Re: 6655 Hollis Street & 1471 67th Street, ALAMEDA COUNTY LOP (**LEAD**)
- CASE #: RO0000063, SAN FRANCISCO BAY RWQCB (REGION 2) - CASE
#: 01-2283; Geotracker: T0600102099.

Request for participation in cleanup process, Water Code §13307.1(b)

Subject: Indoor Air Survey Letter of Findings—1475 and 1483 67th Street, Emeryville, California.

This is Figure 4 from the Stellar Environmental report.

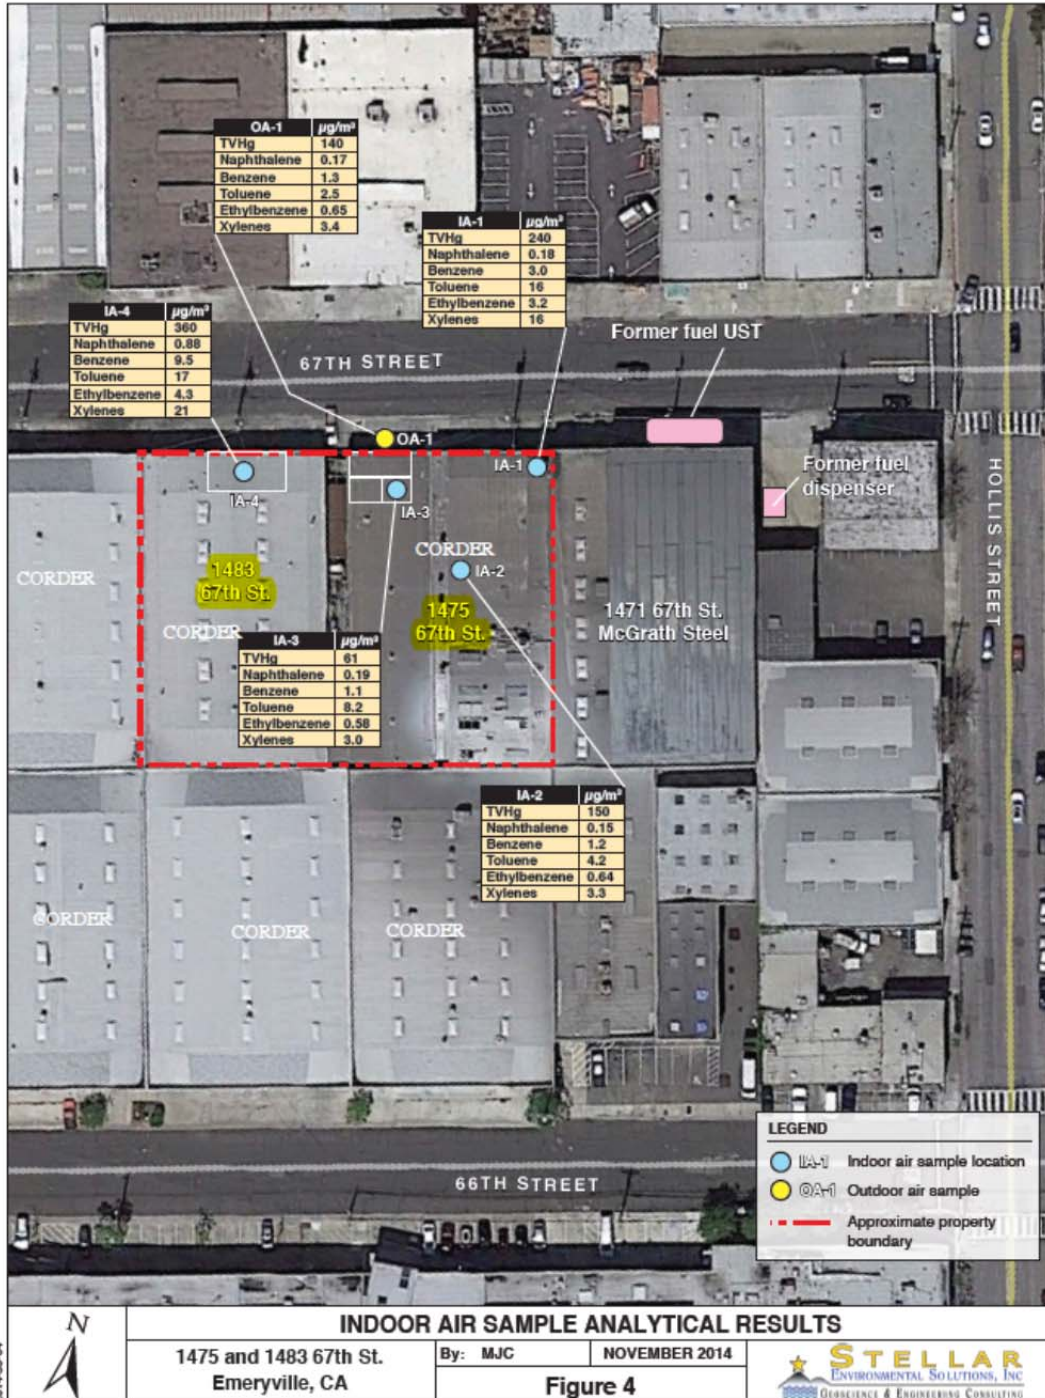
Stellar Environmental found vapor migration and intrusion, indicating likely groundwater and soil contamination from the McGrath Property, under and in the Corder Property, specifically 1475 and 1483 67th Street. (Additional properties on 67th and 66th Streets owned by the limited partnership are adjacent to these two properties.)

- the northeast corner of the 1475 67th Street building (nearest the McGrath USTs)(1A-1, shown on Figure 4 above), and
- the office in the 1483 67th Street building adjacent to 67th Street (1A-4 shown on Figure 4 above).

These higher indoor air values downgradient of the McGrath Property suggest a potentially higher concentration plume may lie beneath the Corder Property. The most expedient and accurate way to determine whether such a plume exists is to do air sampling tests, and borings with grab water sampling. These will better delineate the plume beneath these two downgradient Corder Property buildings.

We believe it is essential that the responsible party, the MCG Group, better define the impact of the releases from the McGrath USTs by sampling sub-slab soil gas and groundwater under the 1475 67th Street and 1483 67th Street properties of my client. The Site Characterization Model should not be prepared until the groundwater plume and soil vapor flux beneath my client’s properties is defined by sampling and testing.
